DOMINION NUCLEAR CONNECTICUT, INC.
MILLSTONE POWER STATION UNIT 3
RESPONSE TO REQUEST FOR ADDITIONAL INFORMATION REGARDING
STRETCH POWER UPRATE LICENSE AMENDMENT REQUEST
REVISED RESPONSE TO QUESTIONS EEEB-07-0052, EEEB-07-0054 AND
EEEB-07-0055

Stretch Power Uprate License Amendment Request
Response To Request For Additional Information
Revised Response To Questions EEEB-07-0052, EEEB-07-0054
And EEEB-07-0055

NRC Question EEEB-07-0052 Follow-Up (EEEB-08-0108)

Figure 1: Pre- and Post-SPU Environmental Temperature Profiles

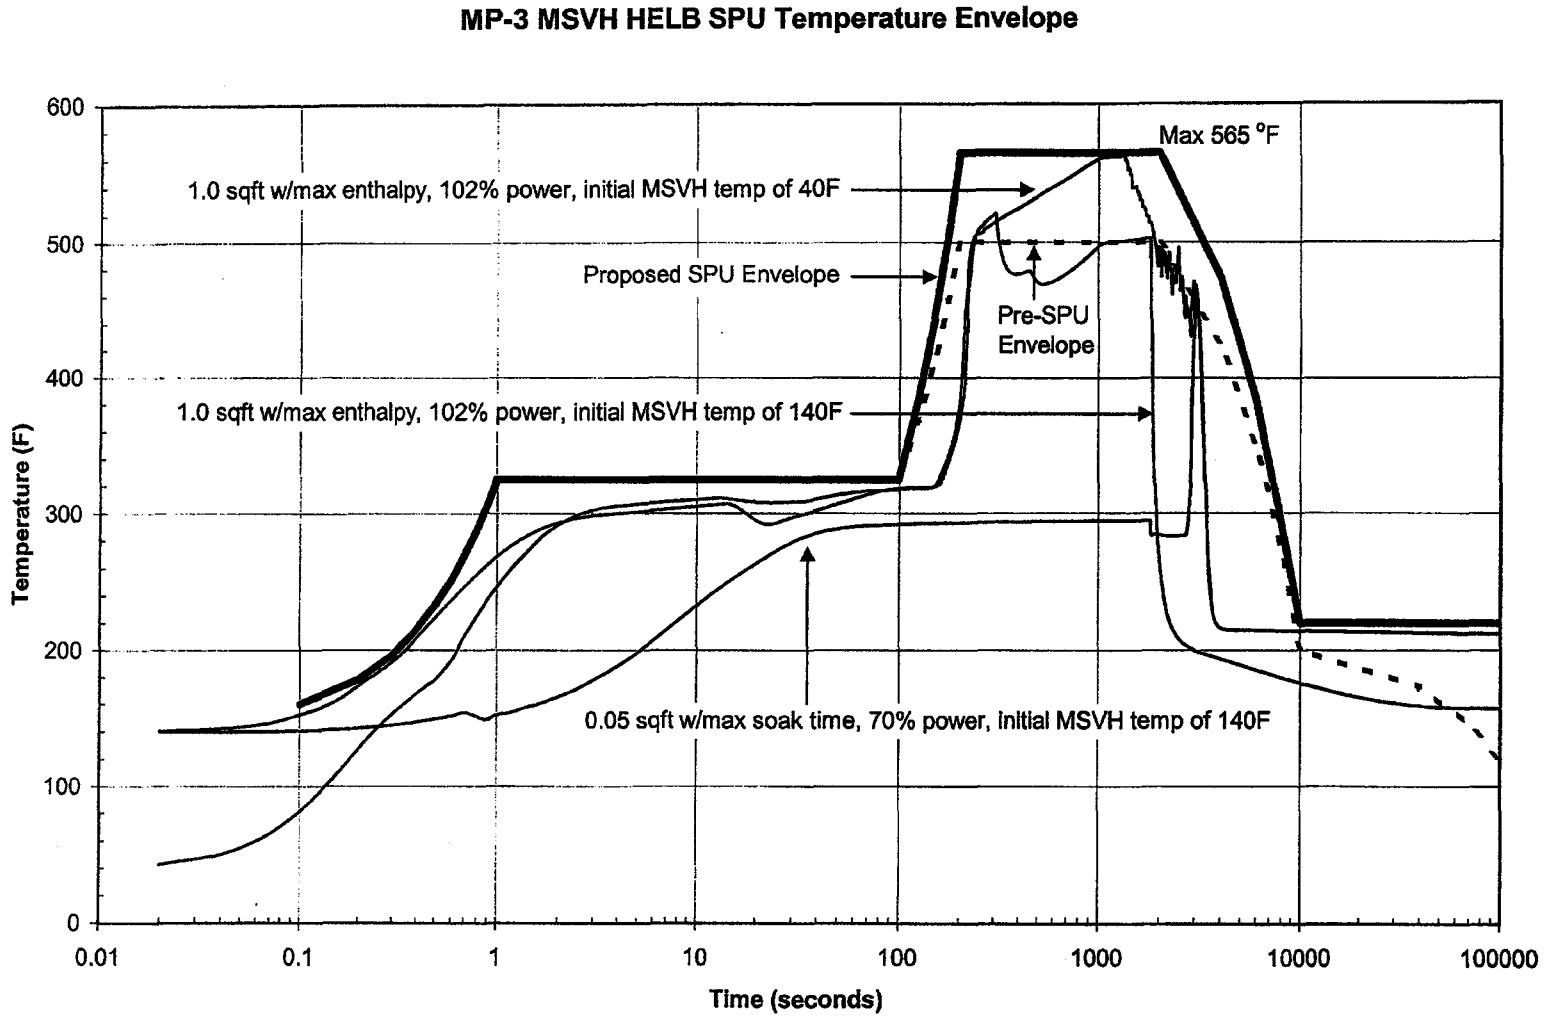
In the March 25, 2008, letter, the licensee states that the analysis for the Main Steam Valve Building (MSVB) following a main steam line break (MSLB) is performed for the duration of the component's mission time. Specify the mission time and function for each of the affected components in the MSVB. Describe the effects of the increased temperature and pressure on the affected components. In addition, explain, in detail, the assumptions and methodology used to evaluate the components. Provide a comparison of the pre-stretch power uprate (SPU) and SPU environmental temperature and pressure profile. Also, provide the detailed environmental qualification (EQ) evaluations and calculations for the ASCO solenoid valves, NAMCo limit switches, Rosemount pressure transmitters, Limatorque motor-operated valves and solenoids associated with Sulzer main steam isolation valves (MSIVs) and ITT actuators.

Provide the worst-case breaks and their impact on the EQ components for the MSVB EQ analysis.

A comparison of the enveloping pre- and post-SPU environmental temperature profiles is provided in Figure 1. The current EQ pressure profile envelopes post-SPU pressure profiles for all cases analyzed. Therefore there is no change to the EQ pressure profile. The enveloping EQ pressure profile is shown in Figure 2.

Figure 3: Pre-SPU Temperature Profiles for ASCO Solenoid Valves

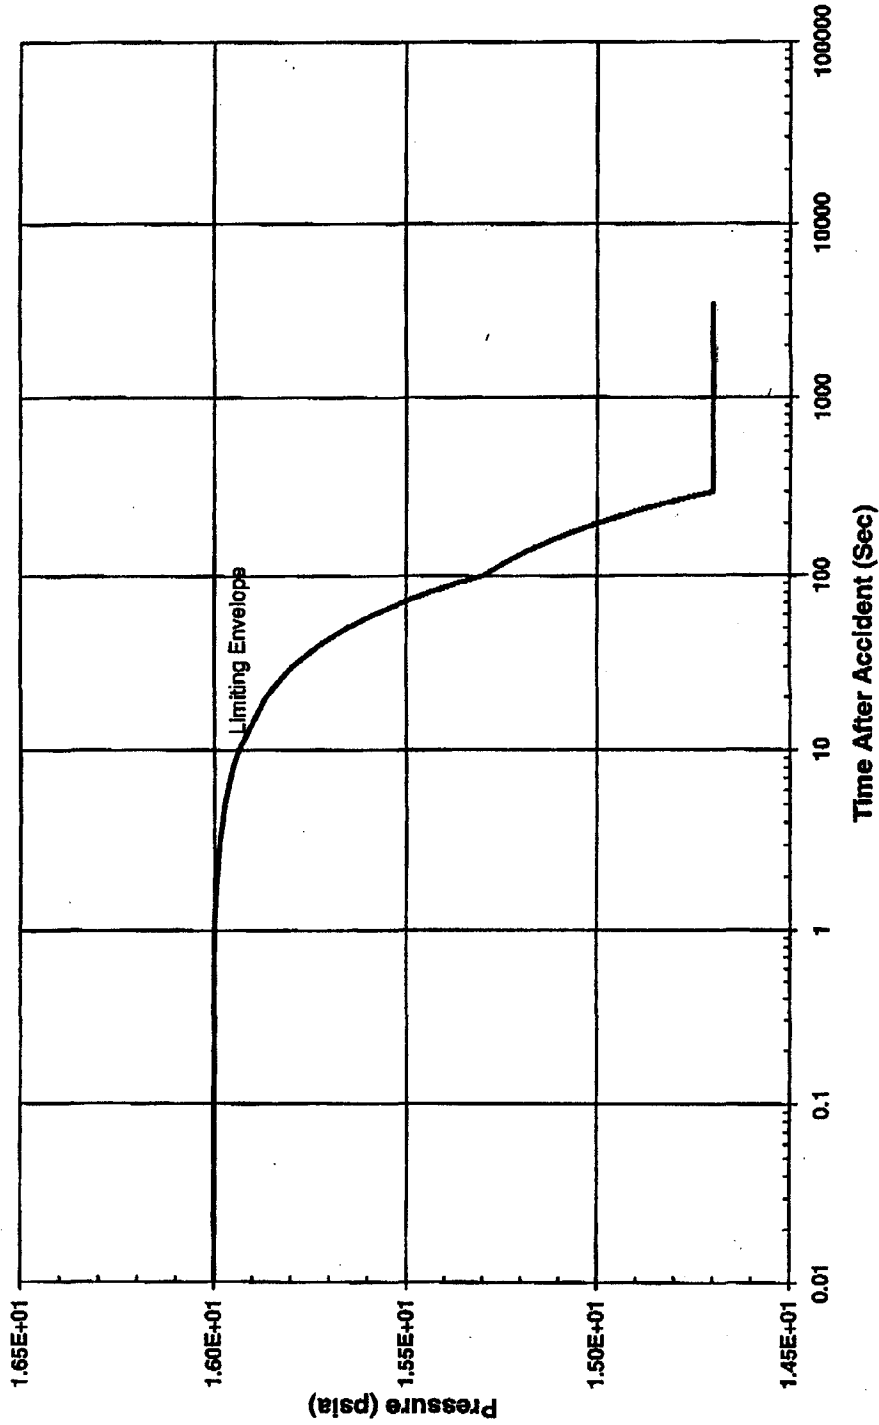
In the March 25, 2008, letter, the licensee states that the outside temperature (i.e. component casing temperature) of the equipment, instead of the internal temperature of the equipment, was conservatively compared with the component qualification temperature. Provide a basis for why the outside temperature is conservative for the affected EQ components.

Pre-SPU ASCO solenoid valve thermal lag analysis used a bounding environment temperature profile (i.e., 1.0 ft² break size, 102% NSSS power level, maximum enthalpy) and a maximum mission time of 1800 seconds. This maximum mission time bounds the MSI times for all break sizes analyzed. The analysis also assumes that the valves are energized to account for coil heat generation. The peak temperatures were determined for the solenoid coil, air gap and coil housing. The maximum post-SPU coil temperature is calculated by conservatively adding the temperature difference between the bounding pre- and post-SPU environment temperature profiles to the calculated peak pre-SPU coil temperature (See note on Figure 3). The peak temperature for pre-SPU environment temperature profile for solenoid valve qualification is 494.2°F (See Figure 3, curve labeled Tamb). The peak temperature identified in the post-SPU environment temperature profile for solenoid qualification is 562.2°F (See Figure 1, curve labeled 1.0 sqft w/max enthalpy, 102%, initial MSVB temperature of 140°F). The pre-SPU solenoid coil temperature at the maximum mission time (1800 seconds) is 377°F (See Figure 3, curve labeled Tcoil). The post-SPU peak coil temperature as identified in the note on Figure 3 is 445°F and remains below the 450°F ASCO solenoid valve qualification temperature.

Note: *post-SPU peak coil temperature = pre-SPU peak coil temperature + temperature difference between bounding pre- and post-SPU environmental profiles*

$$= 377^{\circ}\text{F} + (562.2^{\circ}\text{F} - 494.2^{\circ}\text{F}) = 377^{\circ}\text{F} + 68^{\circ}\text{F} = 445^{\circ}\text{F}$$

Figure 6: Post-SPU Limitorque Motor Temperature Profiles (with insulation)

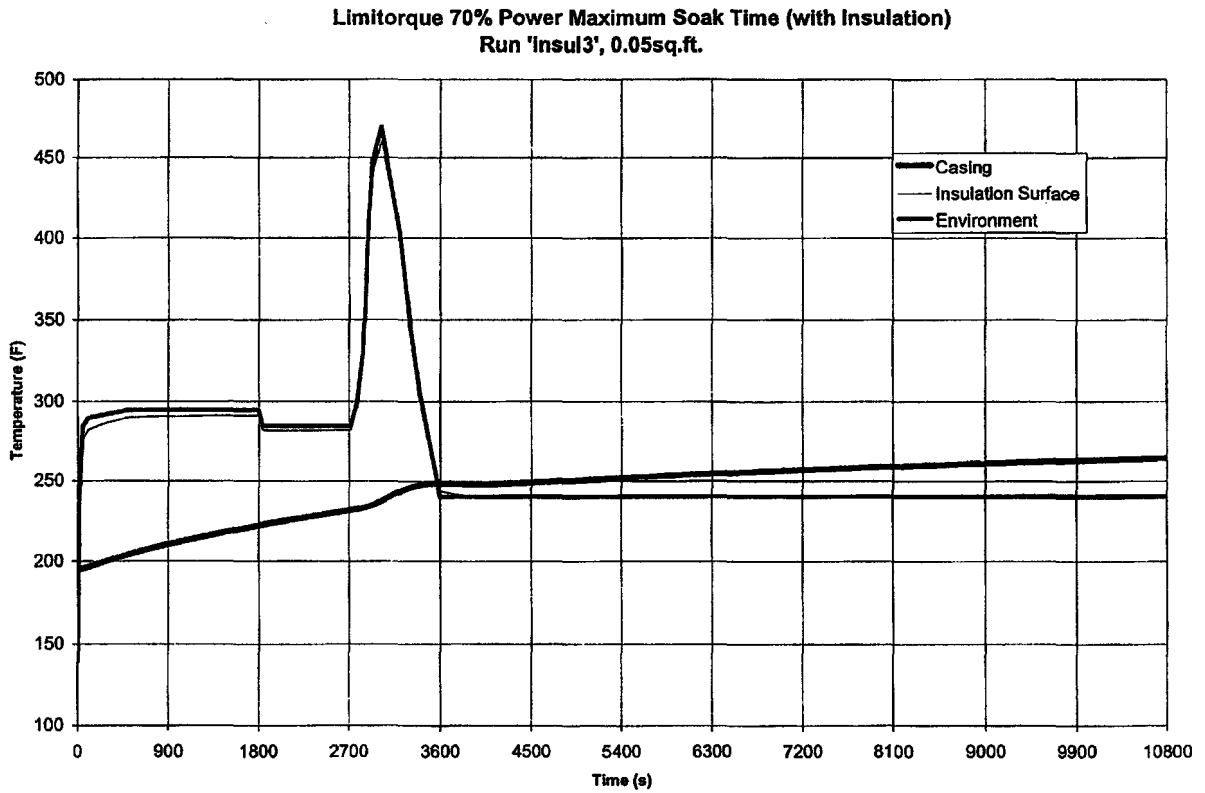
During the March 31, 2008, teleconference, the licensee stated that due to the temperature increase in the MSVB, a design change (enclosing the Limitorque motors with insulation) will be required to maintain the qualification of the motors. Describe the design change in detail and provide a detailed evaluation justifying how this new design, (enclosing the motors with insulation), does not impact the original qualification configuration of the Limitorque motors. In addition, provide a schedule for implementing the aforementioned design change.

Do the motor-operated valves installed in the MSVB use magnesium rotors? If yes, then evaluate the impact of high temperatures on the motors due to the SPU to ensure that these motors do not experience the failure mechanism identified in Information Notice 2006-26 and industry operating experience.

The subject valve bodies contain steam during normal operation. Therefore, the analysis used initial motor casing surface temperatures that are higher than the initial ambient temperature. The analysis was performed using temperature profiles from 0.05 ft² and 0.1 ft² break sizes (double ended guillotine break for a 3-inch diameter line). Four cases for each break size were analyzed: 1) maximum enthalpy at 102% SPU NSSS power level, 2) maximum enthalpy at 70% SPU NSSS power level, 3) maximum soak time at 102% SPU NSSS power level, and 4) maximum soak time at 70% SPU NSSS power level. These cases were chosen to be bounding since they provide the temperature versus time profiles for maximum peak temperature and maximum time for exposure of the component to an elevated temperature prior to superheat and the maximum temperature at the end of the analysis time. The analysis shows that 3MSS*MOV18A/B/C/D motors require insulation to maintain the motor temperature below the qualification temperature during the MSVB HELB event. The most limiting case with insulation was determined to be the maximum soak time at 70% power, 0.05 ft² HELB, insulated case.

The peak MSVB environmental temperatures for all eight cases occur well within 3,600 seconds after break initiation. Therefore, the analysis was run for a period of 10,800 seconds (3 hours). Although the environment temperature drops rapidly after one hour, the analysis assumed a 240.5°F temperature for the remaining portion of the transient. In addition to the external heat flux from the harsh environment to the motor casing, the analysis assumed conductive heat flux from the valve to the motor casing. Therefore comparison of the higher casing temperature to the qualification temperature is conservative. The insulated motor casing temperature at 3 hours is 265°F, which is less than the 315°F motor qualification temperature. Post-SPU temperature profiles of the ambient and the motor casing are provided in Figure 6.

As part of SPU project implementation, a design change will be performed to insulate the 3MSS*MOV18A, B, C and D operator motors prior to exceeding 3411 MWt. The subject motors are totally enclosed, non ventilated motors manufactured by Reliance and do not use magnesium rotors. They are qualified for 100% relative humidity. The design change proposes to install 1.5 inch thick

flexible blanket type insulation covering only the motor. Enclosing the motors with insulation is expected to increase the motor temperature during normal operation and thus, any impact that would reduce the motor service life will be evaluated. The design change process will evaluate the proposed modification to ensure that the installed condition will maintain the original motor qualification (i.e., test condition is applicable to the installed condition). Casing temperatures will be monitored pre- and post-modification, and any impact on the qualified service life will be incorporated into the EQ program for these motors. As part of the design change, plant procedures will be updated such that the motors will be inspected more frequently and replaced when necessary.
